Rehabilitation of the Yosemite Valley Loop Road Project

Finding of No Significant Impact
February 2006

Rehabilitation of the Yosemite Valley Loop Road Project

Public Comment Response Report
February 2006

On page II-3, the National Park Service replaces figure II-1 – Yosemite Valley Loop Road No Action Alternative with figure II-1 (Revised) Yosemite Valley Loop Road No Action Alternative, which can be reviewed on page E5 of this document.

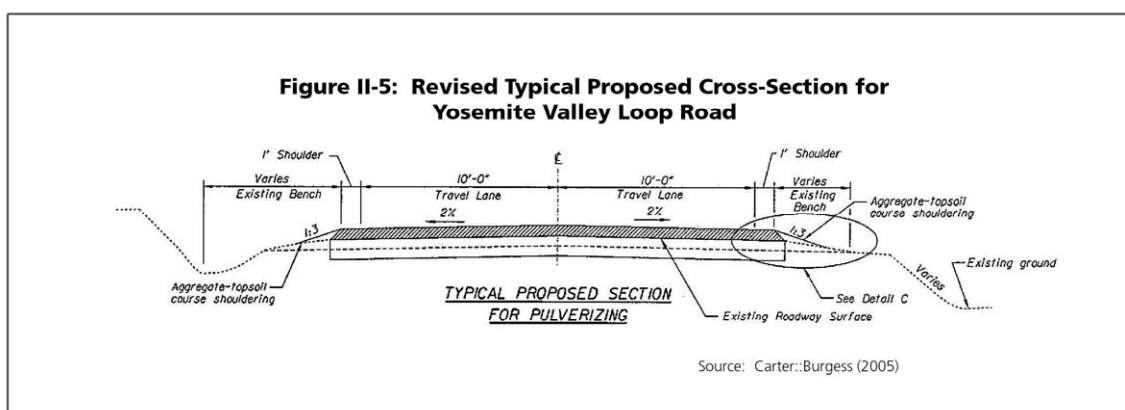
Figures II-1 and II-5 in the *Rehabilitation of the Yosemite Valley Loop Road Project Environmental Assessment* have been replaced with more accurate depictions of roadway cross-sections. Figure II-1 shows a *typical existing* cross-section of the Yosemite Valley Loop Road as well as a base map of the project area. Figure II-5 shows *proposed* cross-sections of different sections of the Yosemite Valley Loop Road. Public comment indicated that both of these figures unclearly presented information pertaining to existing and proposed road widths for the Yosemite Valley Loop Road.

In the EA, figure II-1 depicts a typical cross-section of the existing roadway but did not clearly identify the varied widths of both the existing roadway and shoulder. This figure has been revised in response to public comment to better depict the varied nature of roadway and roadway shoulders. Figure II-1 of the EA has been replaced with figure II-1 (Revised) which can be found on page E5 of the Errata Sheets for the *Rehabilitation of the Yosemite Valley Loop Road Project Environmental Assessment*.

On page II-12, the National Park Service replaces figure II-5 – Typical Proposed Road Improvement Cross-Sections with the following figure II-5 (Revised) and text.

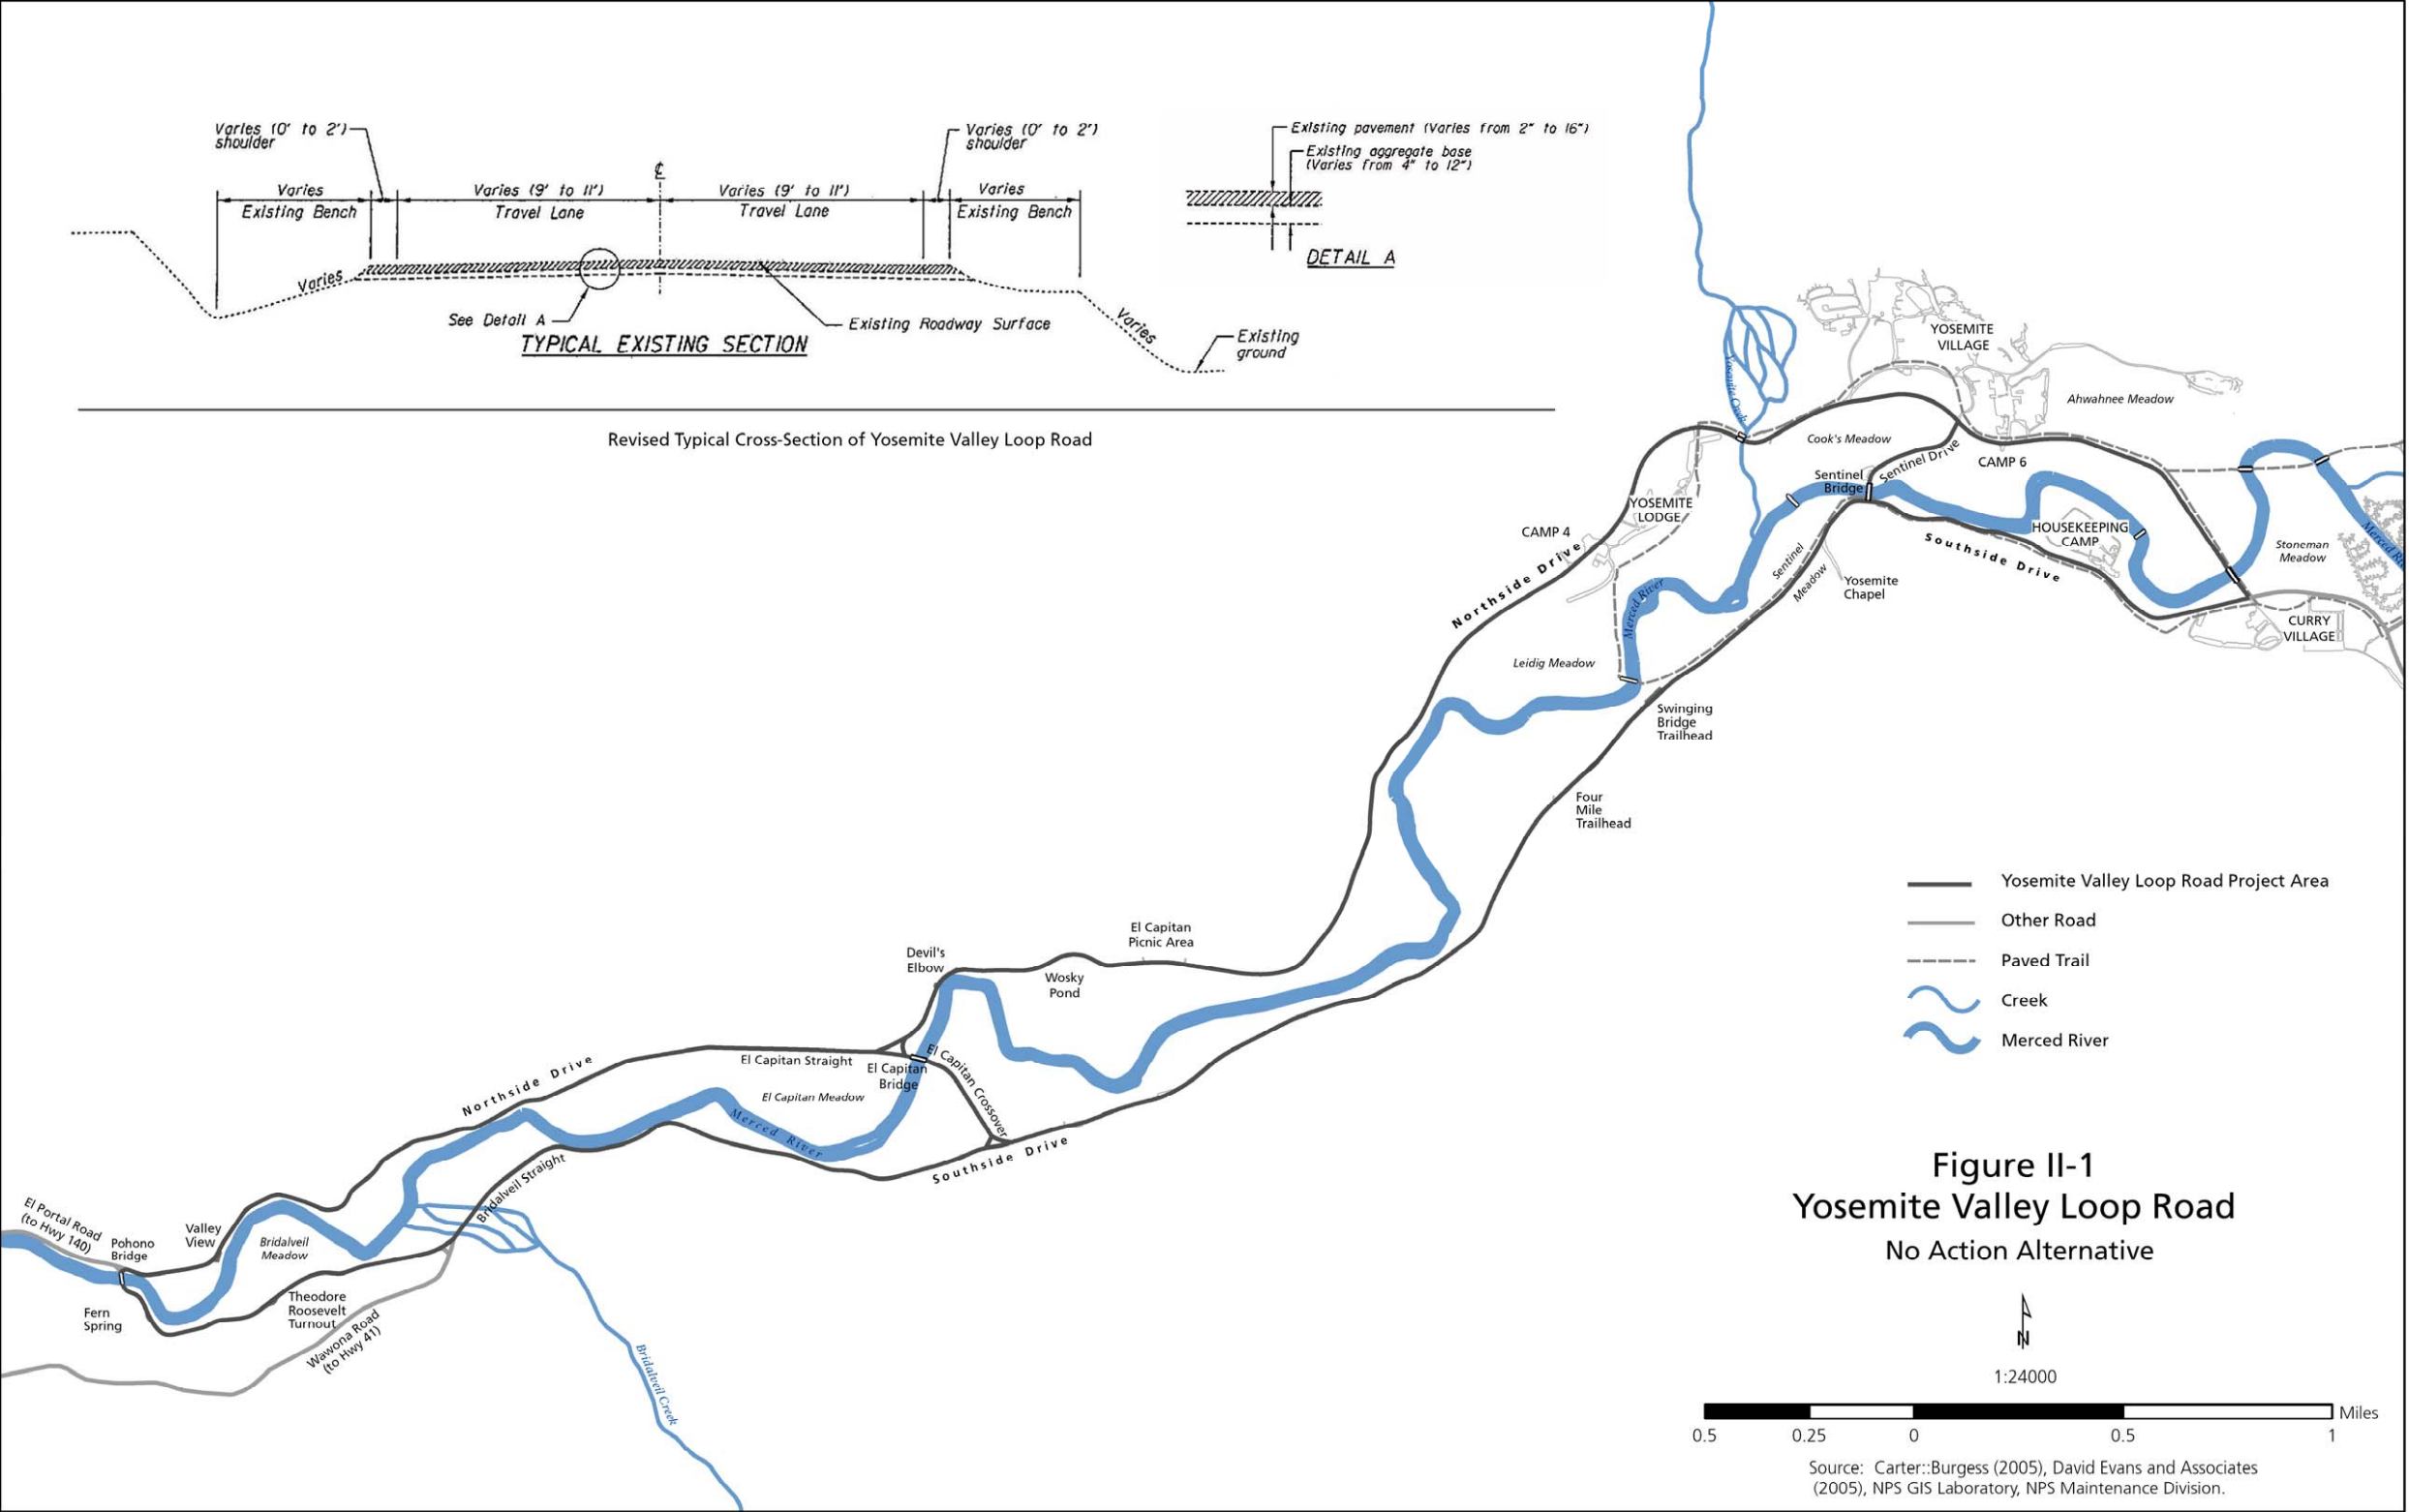
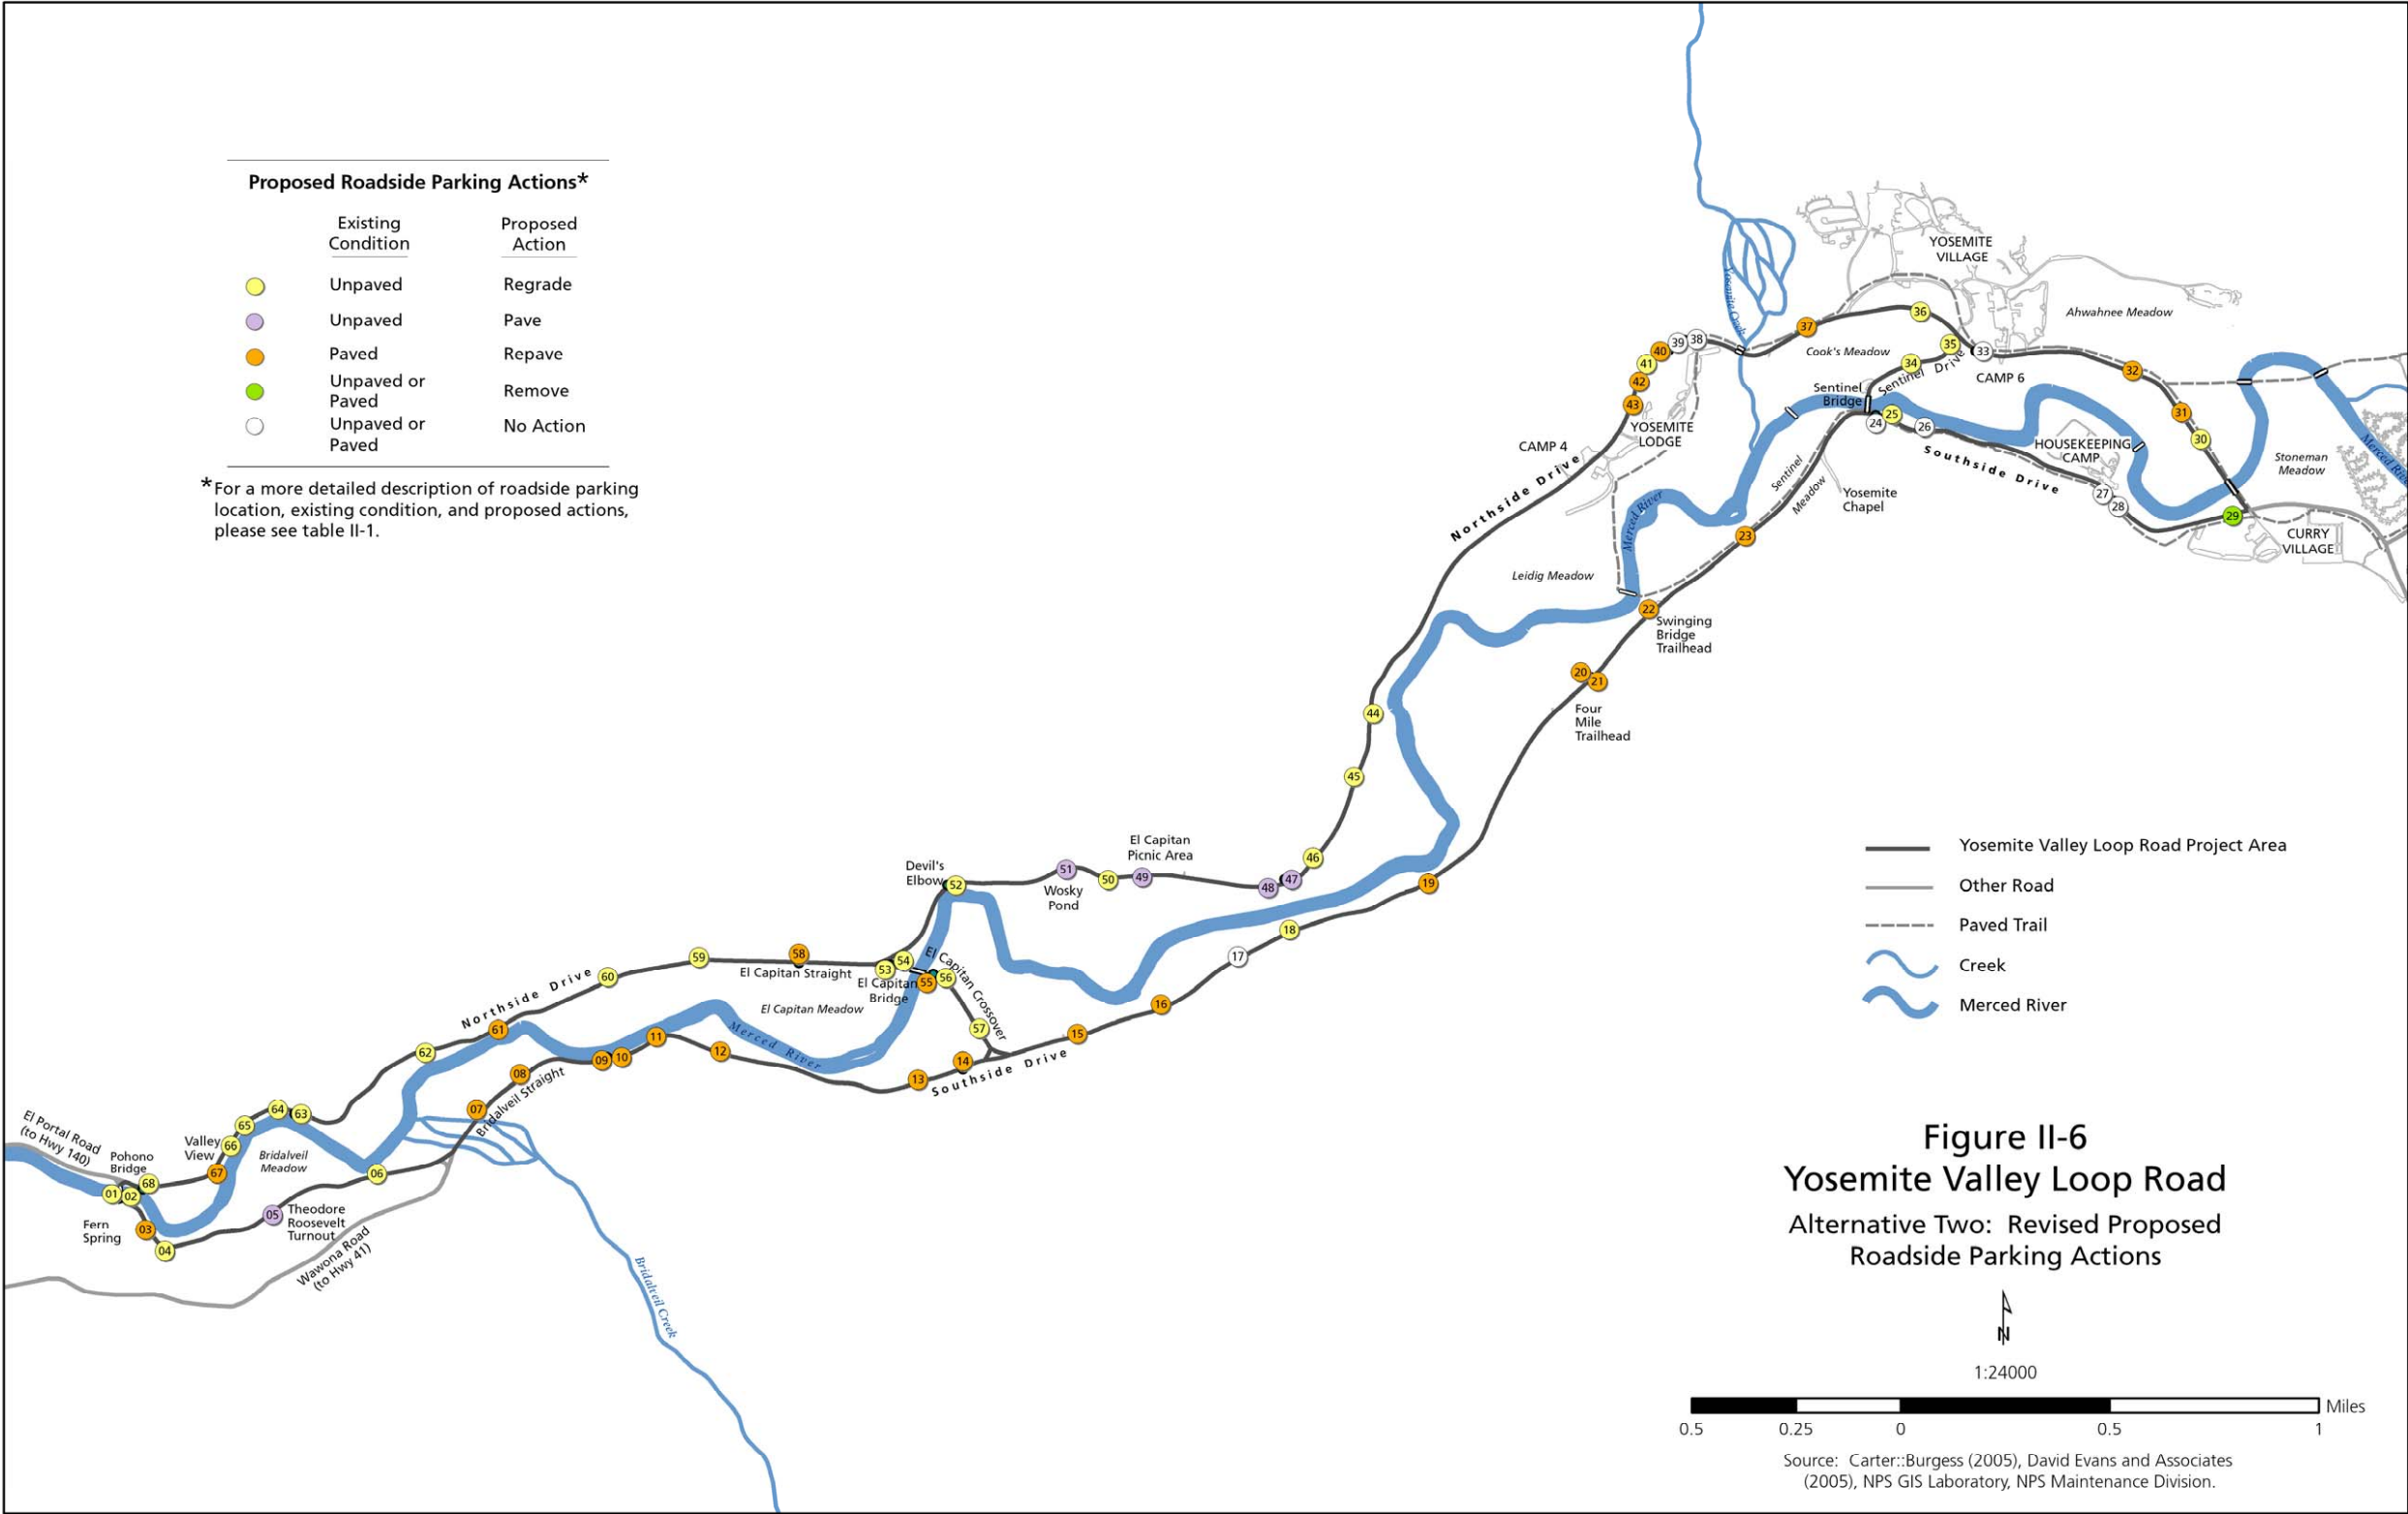
In the EA, figure II-5 depicts a proposed width of travel lanes and shoulders of the Yosemite Valley Loop Road. Figure II-5 (Revised) more clearly illustrates how travel lane and shoulder widths will be made consistent, where possible, to a standard width of 10 foot travel lanes and 1 foot shoulders. Figure II-5 (Revised) replaces figure II-5 of the EA in the Errata Sheets.

“Figure II-5 depicts proposed changes to the Yosemite Valley Loop Road. Travel lane and shoulder widths would be made consistent, where possible, to a standard width of 10 foot travel lanes and 1 foot shoulders. No trees would be removed to achieve these proposed standard travel lane and shoulder widths, nor would the existing road bench be widened to achieve these standard widths. In some locations, the existing roadway width could be made narrower.”
